U.S. Department
of Transportation
**Federal Highway
Administration**

In Reply Refer To: HSA-10/CC-12N

In your May 17, 2005, letter to Mr. Richard Powers, you requested the Federal Highway Administration (FHWA) approval of a modified cable release post (CRP) as an alternative anchor post to the design originally tested and accepted for use with the ET-2000 family of W-beam guardrail terminals and for a high-tensioned cable rail. You also provided information on the results of pendulum testing done to verify that the new design would allow the upper section of the anchor post to release when struck from either direction, yet remain intact when the rail was impacted downstream from the end post to transfer tensile load into the anchor.

CRP WITH 3/4" PLATE Sheet No. 1 of 4

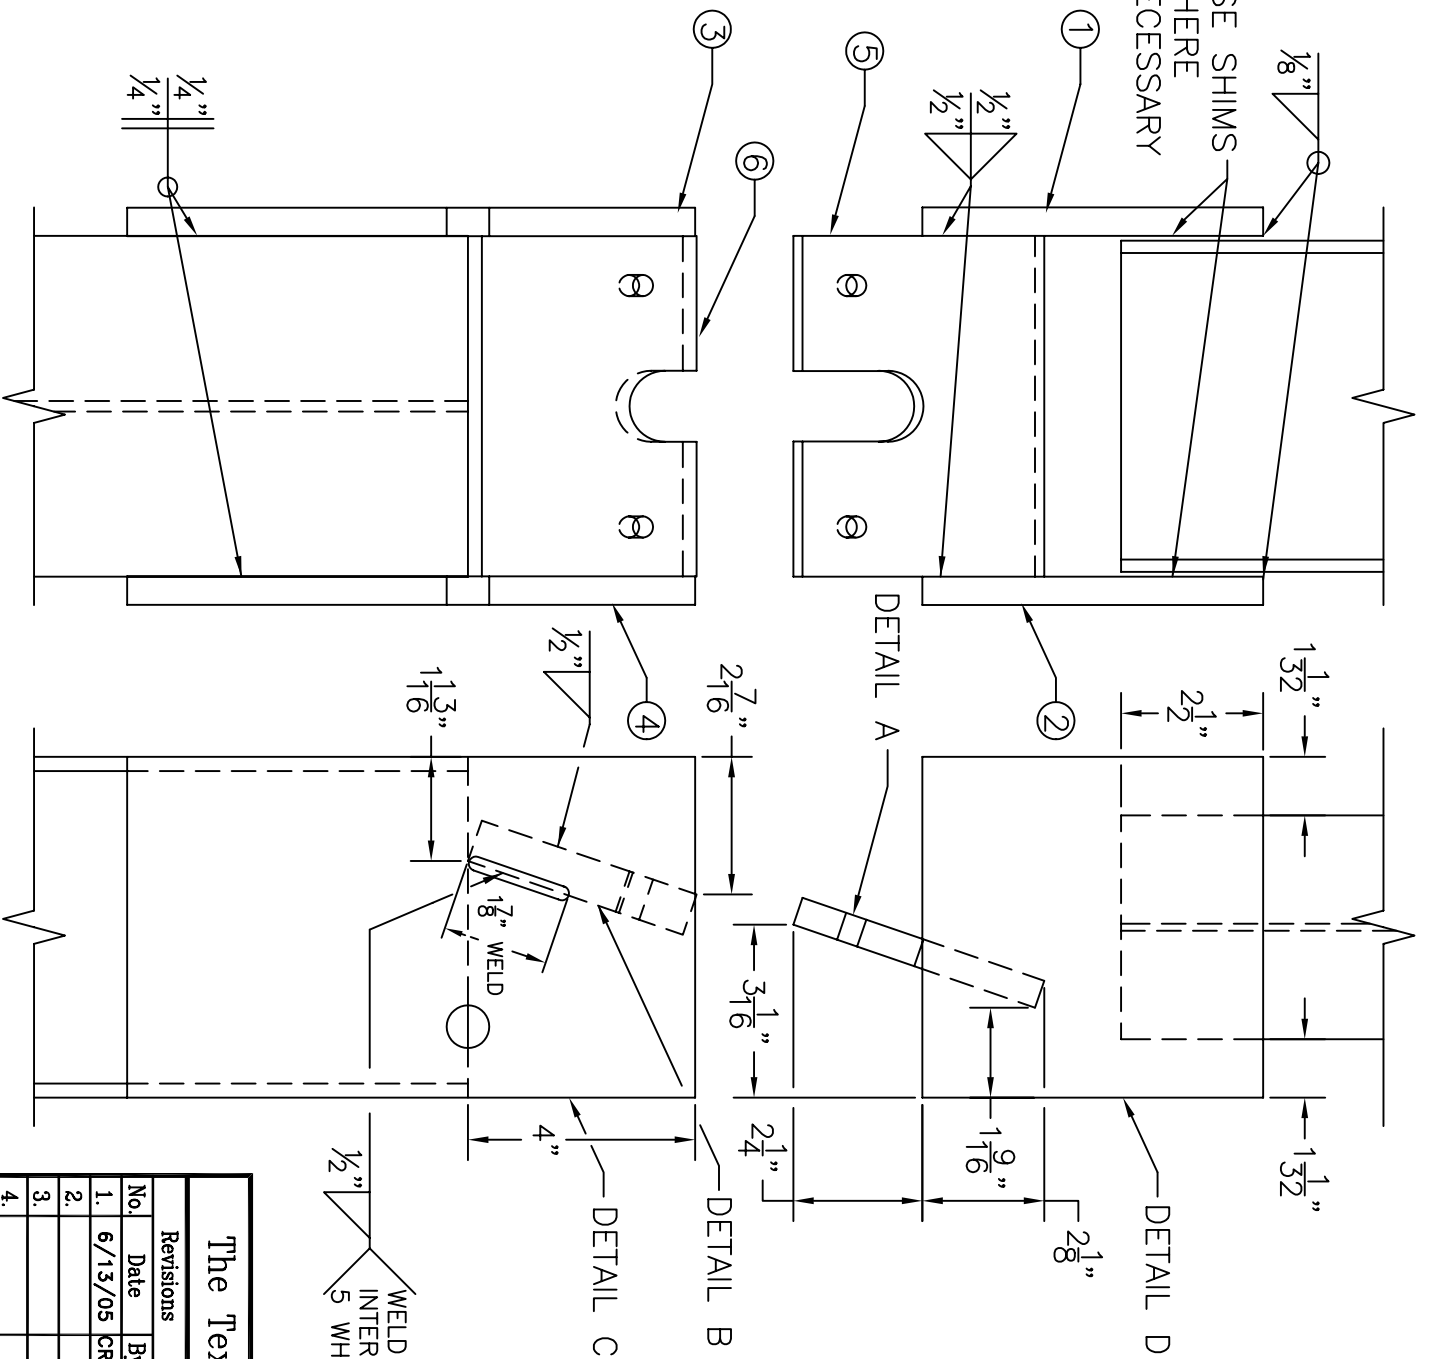
You stated that the primary design change was the use of 1/2-inch and 3/4-inch thick flat steel plate to form the upper and lower inclined surfaces, respectively, in lieu of the channel sections used in the original design. Additionally, the steel side plates on the bottom post were lengthened to reduce deformation of the post flanges under loads, thereby reducing maintenance requirements. These changes are shown as an enclosure to this letter.

I agree that the changes described above and depicted in the enclosure are not likely to affect the performance of any currently approved ET designs or your cable anchor and that the new post can be considered an acceptable alternative design to the end post that was described in the FHWA acceptance letters CC-12J, dated June 24, 2002, and CC-76, dated August 29, 2002.
